Schematic Development Amendment SDPA-3-11

Schematic Development Amendment SDPA-3-11.: Request to amend an approved Schematic Development Plan to reconfigure the location of building and parking facility, add to the height of the previously approved building, correct the size of the property and accommodate current environmental regulations and requirements for a property consisting of approximately 2.06 acres of land in the O-M Zone, located at 19815 Blunt Road in Germantown, Maryland.

Germantown Employment Area Sector Plan

SUBJECT: Schematic Development Plan Amendment No. SDPA-11-03
Plumgar Property
Germantown

Proposed SDP

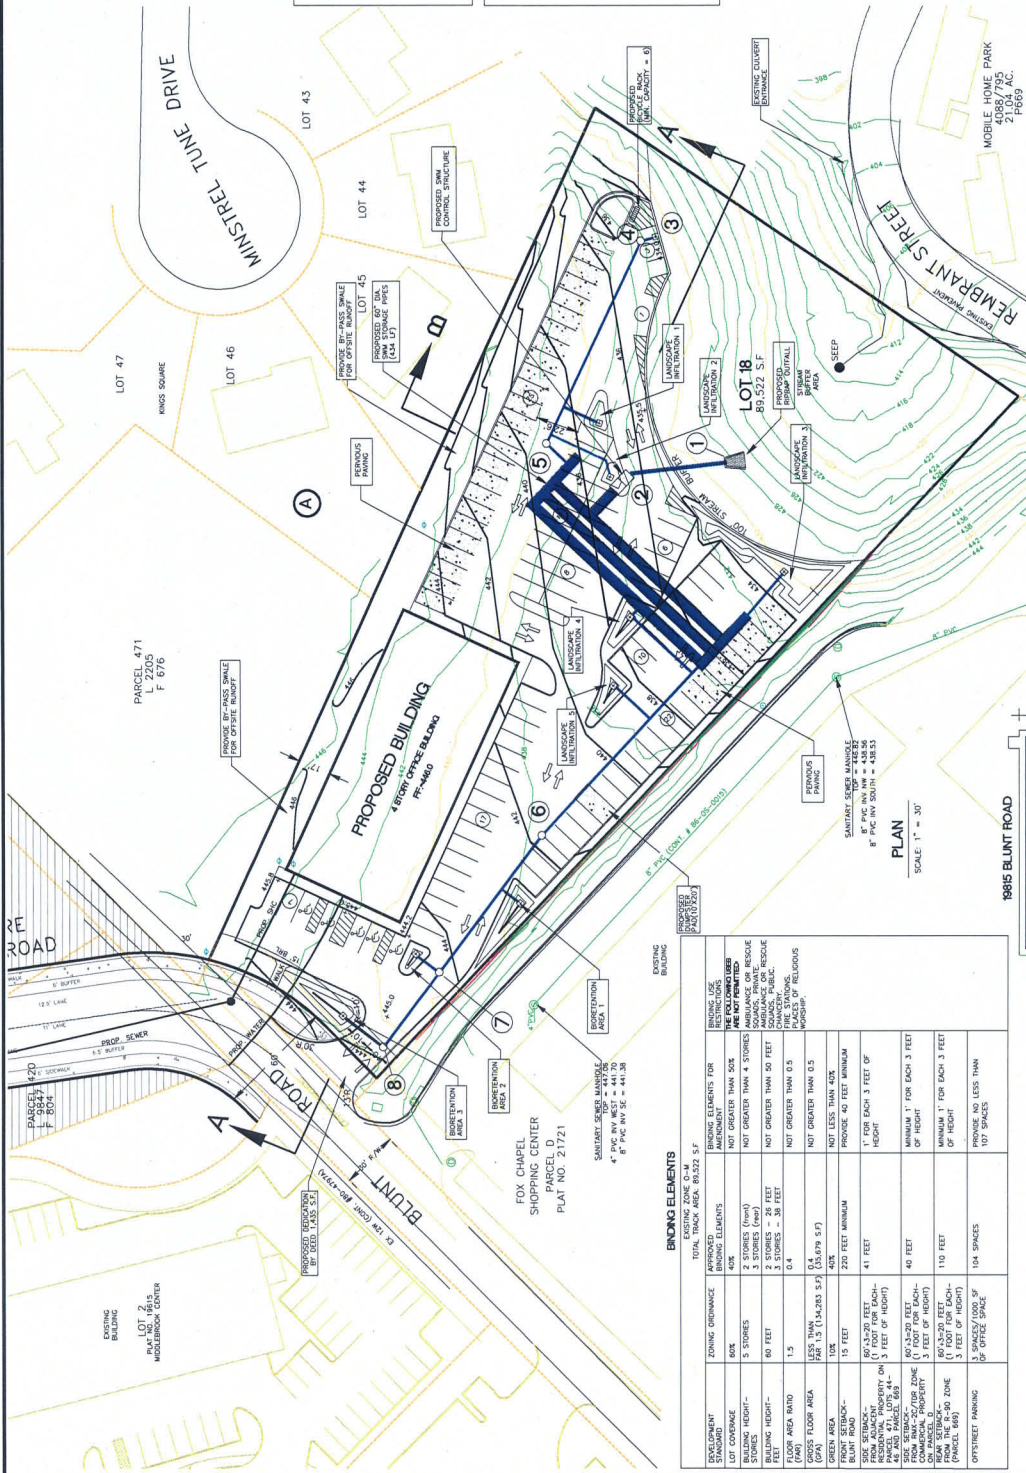
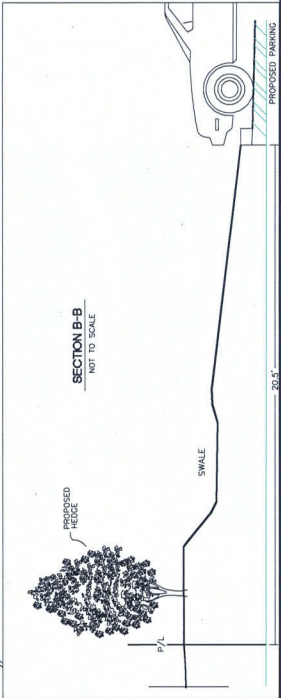
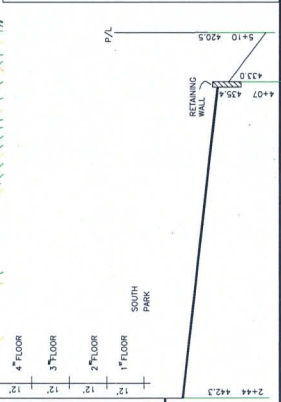
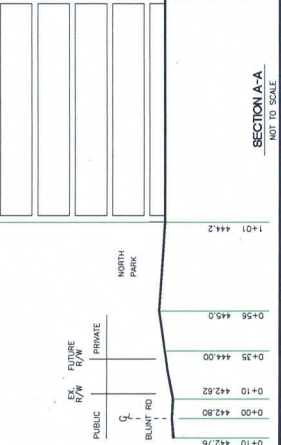
Staff recommends that the binding element related to the number of parking spaces be deleted since the number of required parking spaces cannot be determined until Site Plan review. Staff also recommends that "Places of Religious Worship" be removed from the binding elements since "places of religious worship" are allowed by right in any zone as long as they meet zoning.

1. Required setbacks from the adjacent R-60 zoned property to the north, at Parcel 471, should be verified. Setback requirements for the adjacent sing. fam. detached lots to the north should also be verified and checked with the data table. A 3 to 1 setback requires a minimum setback of 16 ft. and 17 ft. is shown on the plan adjacent to Parcel 471. Final grading may require a larger setback.

2. Continuous, dense landscape planting as screening for the surface parking areas is necessary at the northeast and southwest site property lines. A revised binding element for adequate screening at the site perimeter is necessary for the SDP; e.g., the binding element could read - "At the time of Site Plan the Applicant will provide a Landscape Plan to include a continuous hedge and a berm at the northeast property line and adequate planting for screening of the surface parking areas at both the northeast and southwest perimeter of the site.

4. The Blunt Road frontage area of the project, as shown with the SDP, is significantly constrained. This should be addressed at the time of Site Plan.

PRELIMINARY FOREST CONSERVATION PLAN

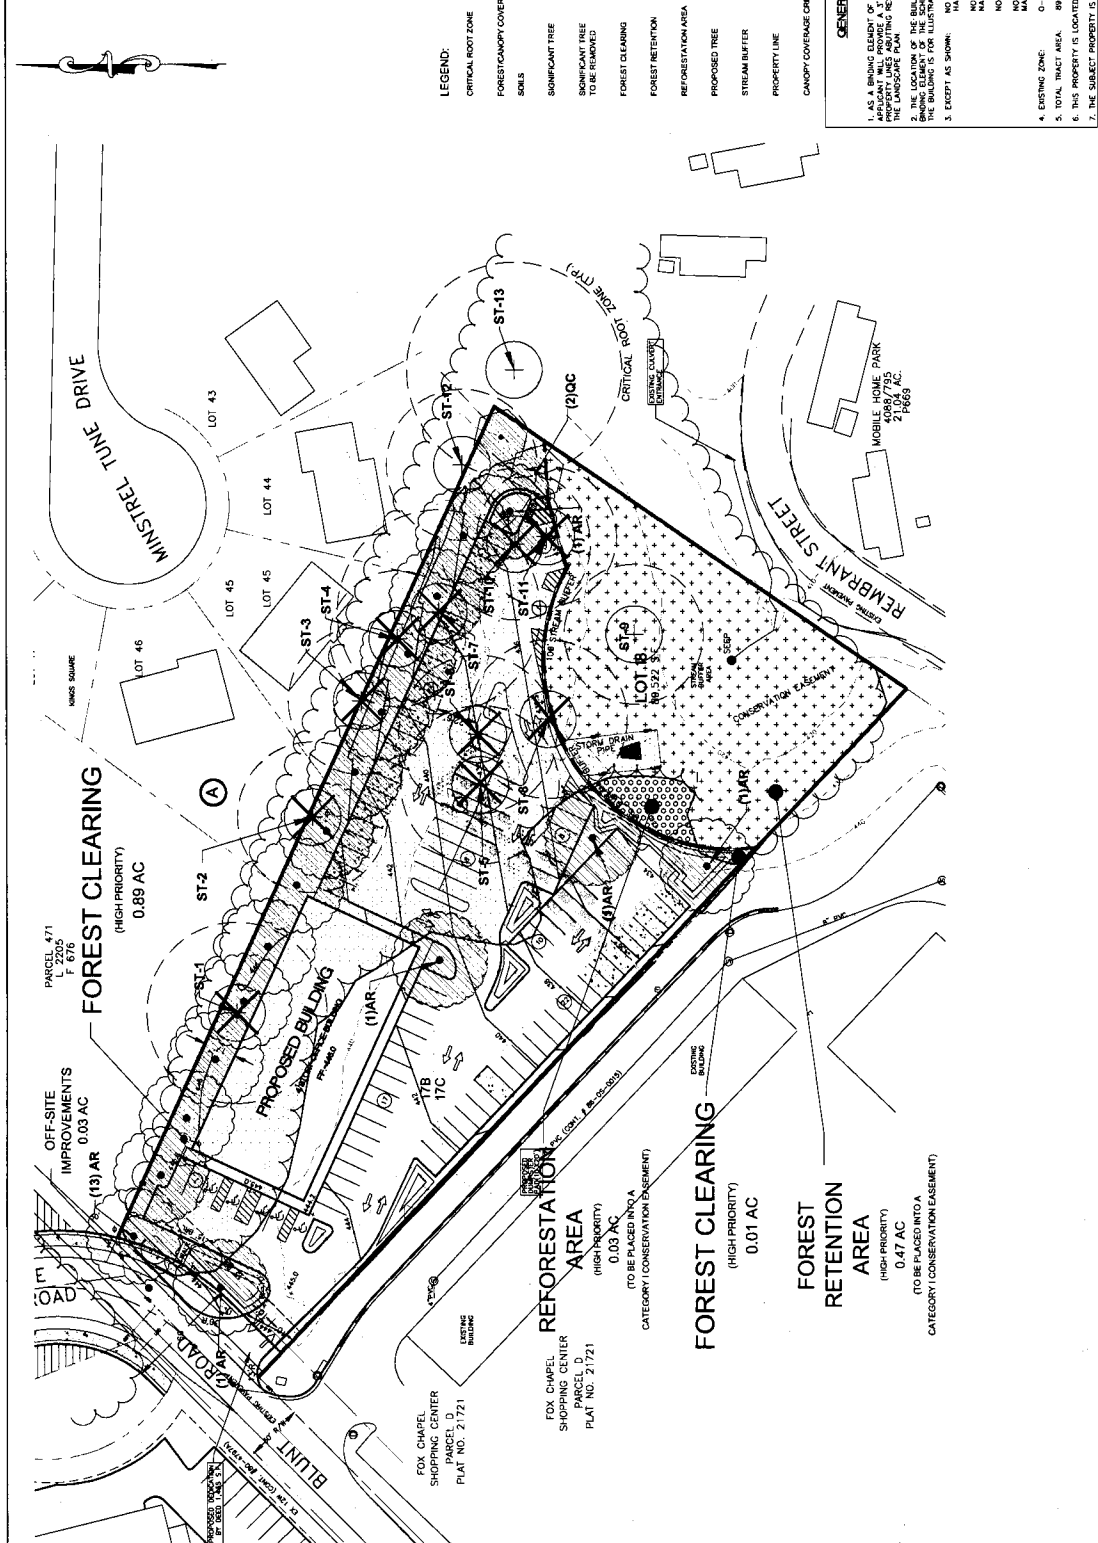
The applicant has submitted a preliminary FCP. The following comments are based on a conceptual review (see attached memo dated 1/16/2012 from Mary Jo Kishter). Additional comments and recommendations will be provided at time of formal FCP submission with the Site Plan.

1. Staff recommends that the applicant strive to retain an additional 1,307 square feet of forest on-site, adjacent to the forest proposed to be retained within the environmental buffer. This would result in a planting requirement of 0.03 acres that could be met by reforesting the portion of the environmental buffer that is not forested (priority area). This

2. If the applicant is not able to retain the additional forest as described above, credits from proposed onsite landscaping or payment of fee-in-lieu to the M-NCPPC forest conservation fund may be acceptable to meet the remaining forest conservation requirement. The applicant will need to provide evidence that the landscape areas will provide adequate soil volume for the plants to thrive and reach their 20-year canopy coverage for which credit is given. Additionally, the area of projected 20-year canopy coverage credit may not overlap with the other trees receiving credit (areas may not count more than once towards meeting the forest conservation requirement). The Forest Conservation Plan will need to show the projected 20-year canopy of each of the trees for which forest conservation credit is proposed. Again, the preference is to retain as much forest as possible onsite to avoid reforestation. The 0.03 acres of reforestation proposed in the environmental buffer is a priority area and staff supports this.

1. Staff recommends that the applicant strive to retain an additional 1,307 square feet of forest onsite, adjacent to the forest proposed to be retained within the environmental buffer. This would result in a planting requirement of 0.03 acres that could be met by reforesting the portion of the environmental buffer that is not forested (priority area). This reforestation is currently shown on the provided FCP. The additional 0.04 acres of required reforestation would not be necessary.

2. If the applicant is not able to retain the additional forest as described above, credits from proposed onsite landscaping or payment of fee-in-lieu to the M-NCPPC forest conservation fund may be acceptable to meet the remaining forest conservation requirement. The applicant will need to provide evidence that the landscape areas will provide adequate soil volume for the plants to thrive and reach their 20-year canopy coverage for which credit is given. Additionally, the area of projected 20-year canopy coverage credit may not overlap with the other trees receiving credit (areas may not count more than once towards meeting the forest conservation
